# DA Stage Access Assessment Report

## The Landmark St Leonards

<b>Project:</b>	The Landmark St Leonards
<b>Reference No:</b>	115389-Access-r3
<b>Date:</b>	1 July 2022
<b>Client:</b>	New Hope Evergreen
<b>Client Contact:</b>	Alistair Cook
<b>Email:</b>	<a href="mailto:Alistair.Cook@newhopegroup.com">Alistair.Cook@newhopegroup.com</a>
<b>BCA Logic Contact:</b>	Cameron Clark
<b>Direct:</b>	(02) 8484 4095
<b>Email:</b>	<a href="mailto:Cameron.clark@jensenhughes.com">Cameron.clark@jensenhughes.com</a>

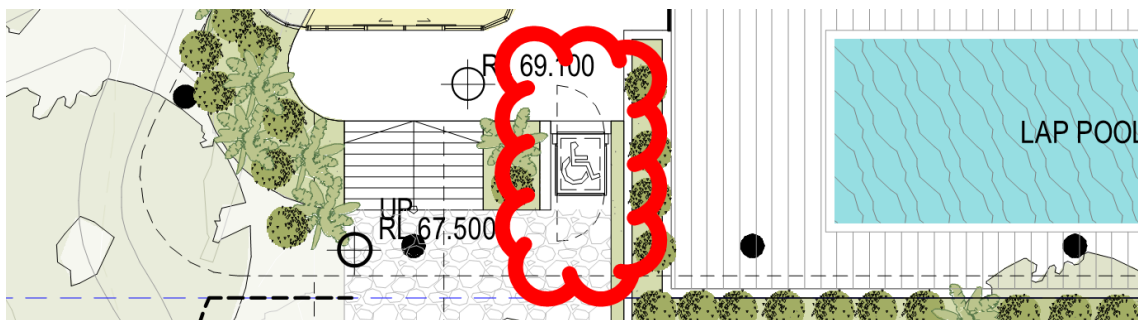
1. The Tower 2 Gym doorways shall be provided with a single operable leaf with a clear opening width of not less than 850mm and door circulation space satisfying AS1428.1-2009, or alternatively both door leaves shall be automatic opening with accessible push button hardware complying with AS1428.1-2009.

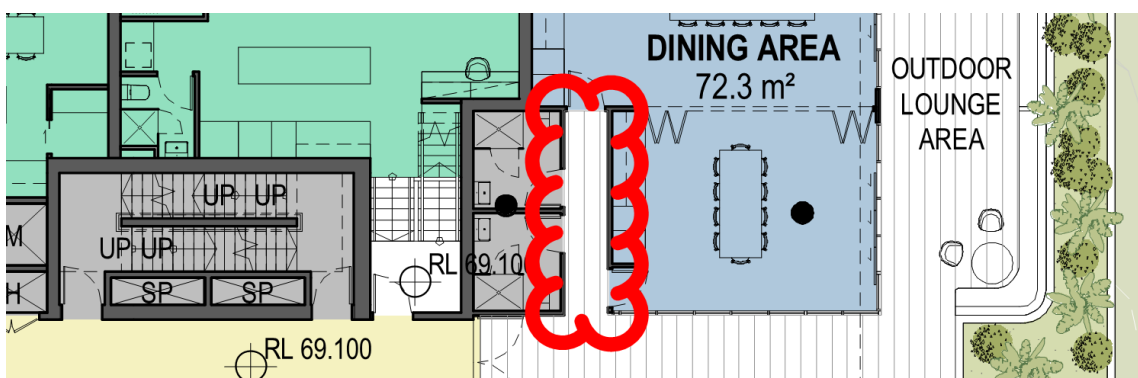
2. The low-rise, low-speed constant pressure lift shall have clear floor dimensions of 1100mm wide and 1400mm deep, and shall be provided with door latch circulation space complying with AS1428.1-2009 or alternatively the lift doors shall be automatic opening with accessible push button hardware complying with AS1428.1-2009.

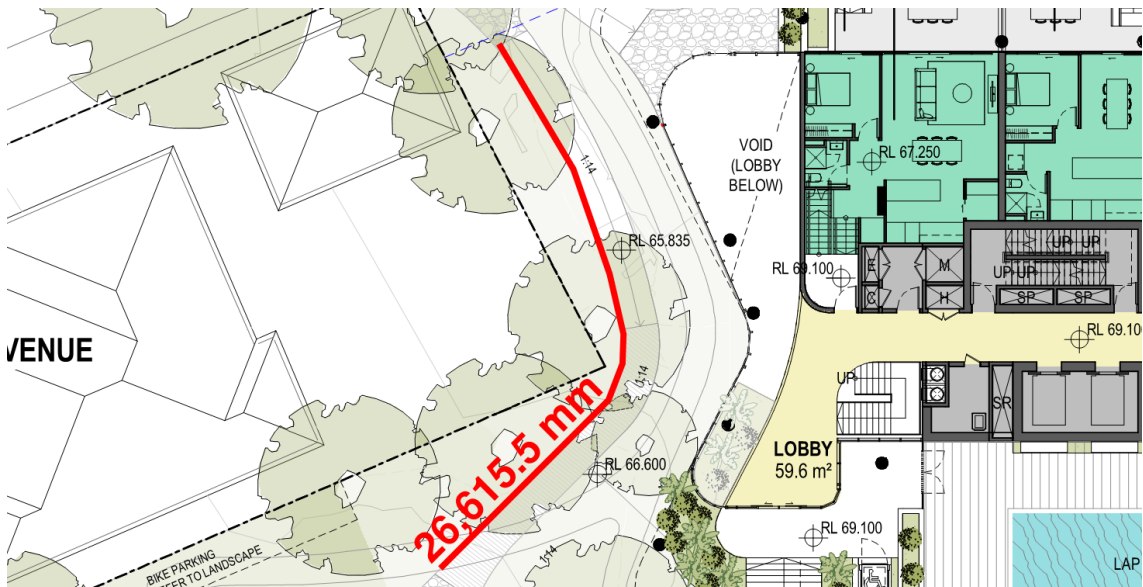
3. Circulation spaces for persons with disabilities to access Tower 1's Level 1 common dining area shall be provided in accordance with BCA D3.1, D3.3 and AS1428.1-2009.

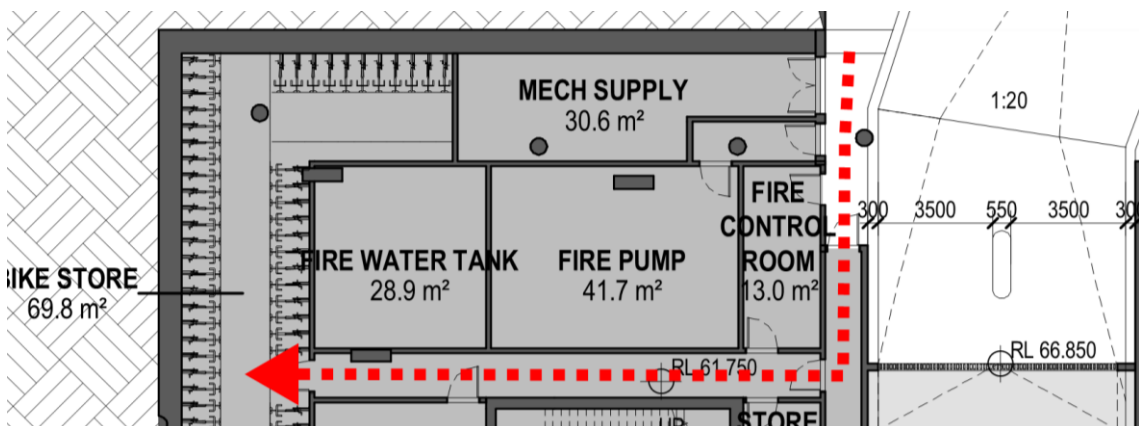
4. A central 1800mm wide x 2000mm deep wheelchair passing space shall be provided to the external series of 1:14 ramps from the Canberra Ave entrance in accordance with BCA D3.3 and Figure 3 of AS1428.1-2009 to ensure that passing spaces are at not more than 20m intervals along the accessway.

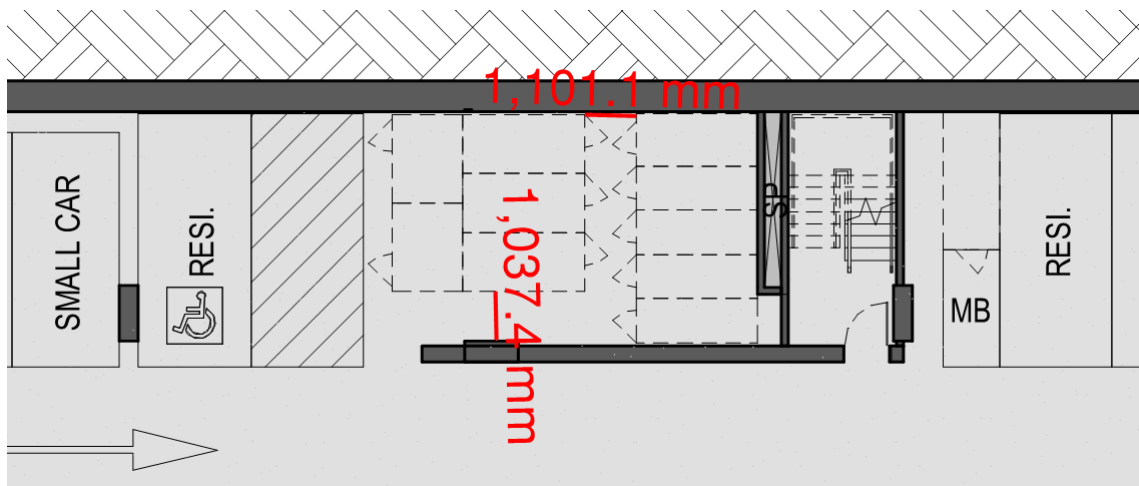
5. Access for people with a disability shall be provided to the Basement 1 bike store in accordance with BCA D3.1, D3.3 and AS1428.1-2009.

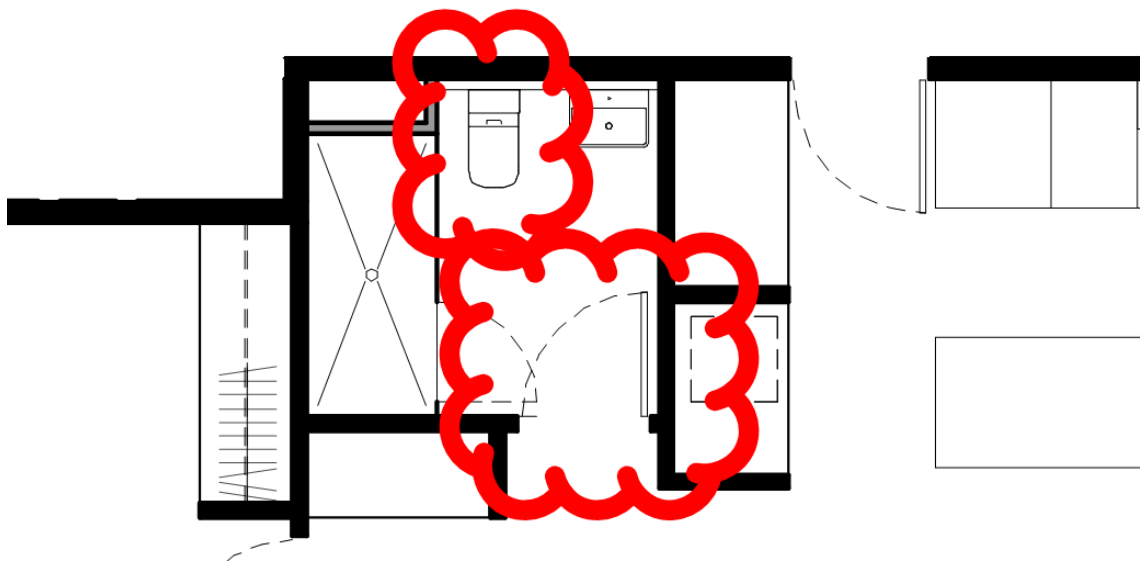
7. Unit layouts are to be provided for all visitable sole-occupancy units required by the Lane Cove DCP demonstrating that they have wheelchair accessible entrances (850mm wide doorways with lobby-side door circulation space complying with AS1428.1-2009) with 1m wide corridors/hallways and 820mm doorways for the path of travel leading to, and connecting, the living area and a visitable toilet, consistent with AS4299-1995's definition of requirements for visitable units.
8. Pre-adaption, the toilets within the visitable, livable and adaptable sole-occupancy units shall be located in the corner of the rooms in accordance with AS4299-1995 and the LHDG. In the below example, it should be swapped with the washbasin. This issue occurs in various sole-occupancy units.

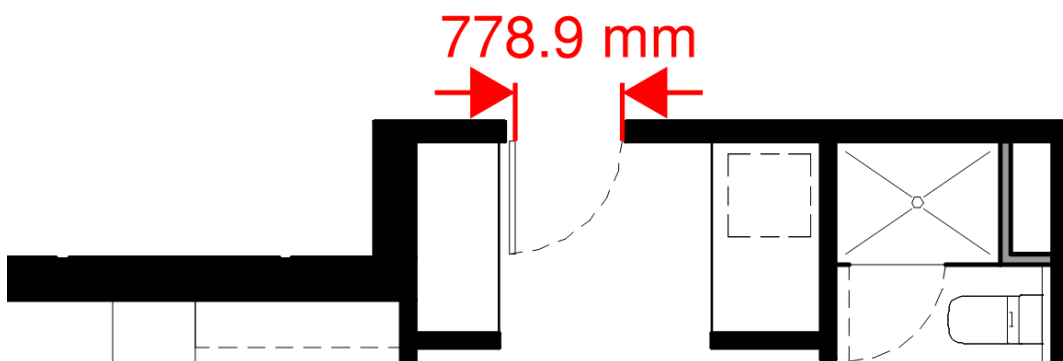
Additionally, the doorway shall be swung outwards (or swing both directions) to ensure that the door swing does not encroach into the 1250mm deep x 900mm wide clearance required forward of the closet pan. The doorway encroachment issue occurs in several sole-occupancy units. The closet pan clear space must be clear of the door swing.

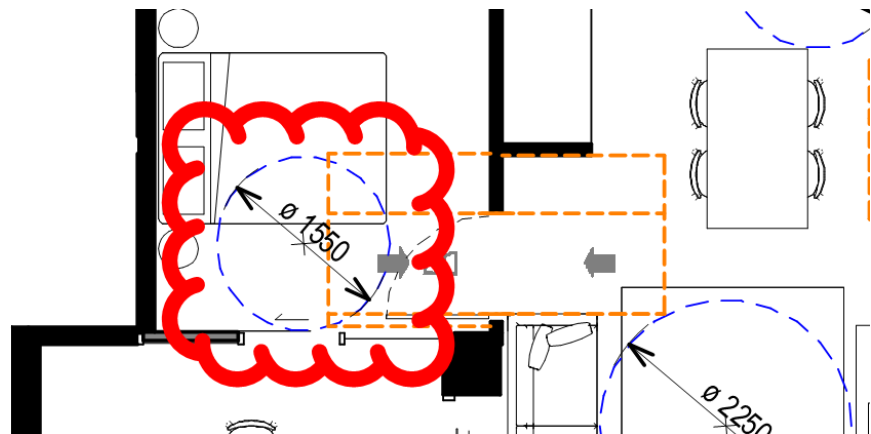
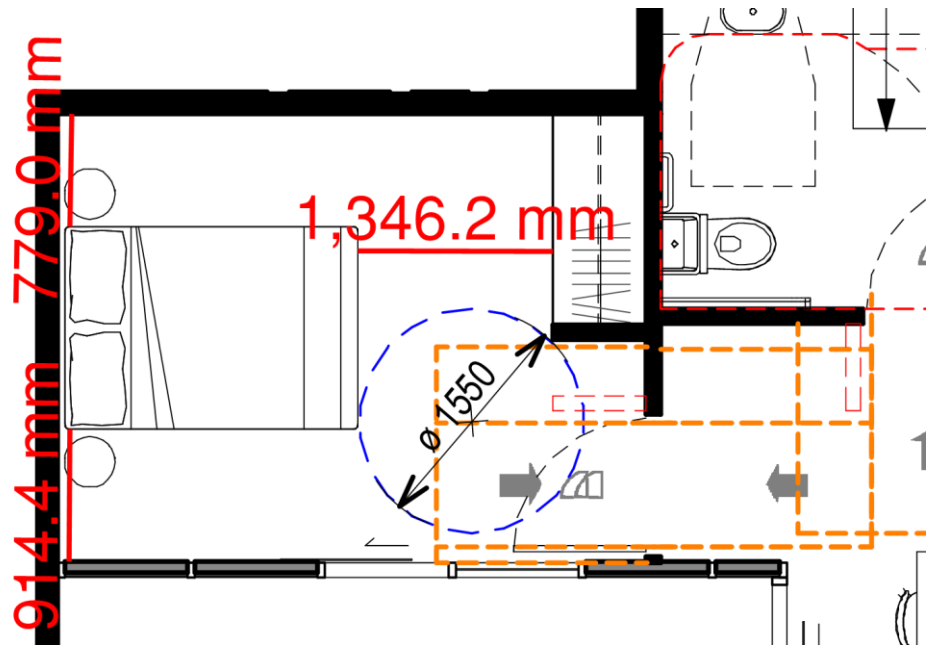
9. Pre-adaption, the sole-occupancy unit entry doors shall have a clear opening width not less than 850mm in accordance with AS4299-1995. This issue occurs in the 2 Bed Type 1 sole-occupancy unit only.

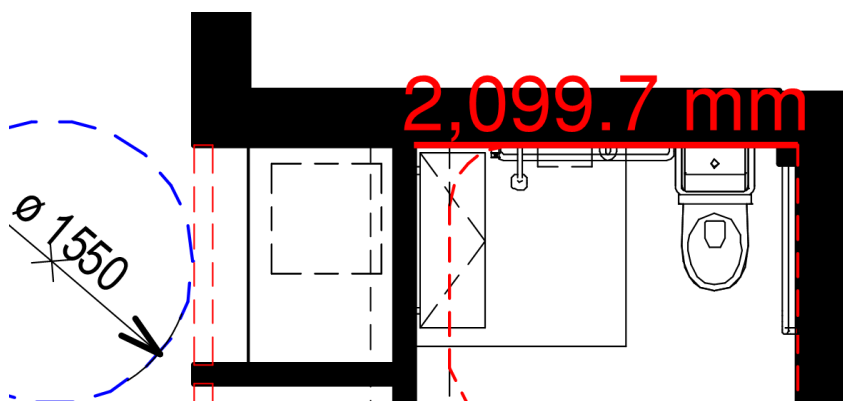
10. Post-adaption, the bedrooms shall have 1540mm clear for the entirety of one side or at the foot of the bed, and 1m clear for all other sides of a queen size bed in accordance with AS4299-1995 and Clauses 24.3 and 6.2 of AS1428.2-1992. This bedroom clearance issue occurs in all sole-occupancy units.

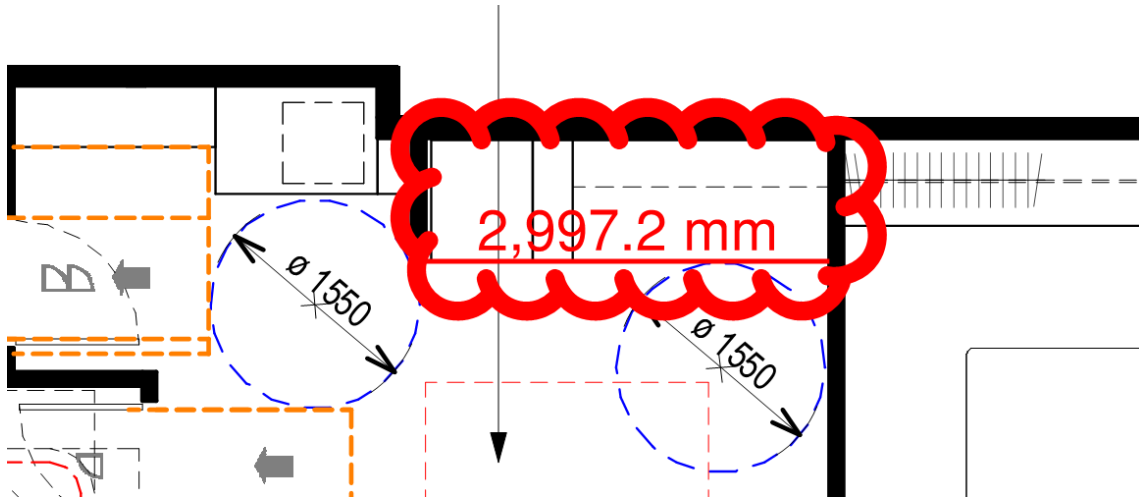
11. Post-adaption, an accessible bathroom shall be provided complying with AS1428.1-2009. In the below example, the bathroom is too narrow and should be no less than 2350mm wide to ensure that all shower and closet pan circulation spaces can be achieved clear of fixtures. This issue occurs in various sole-occupancy units where the bathrooms are too narrow to be able to comply with AS1428.1-2009.
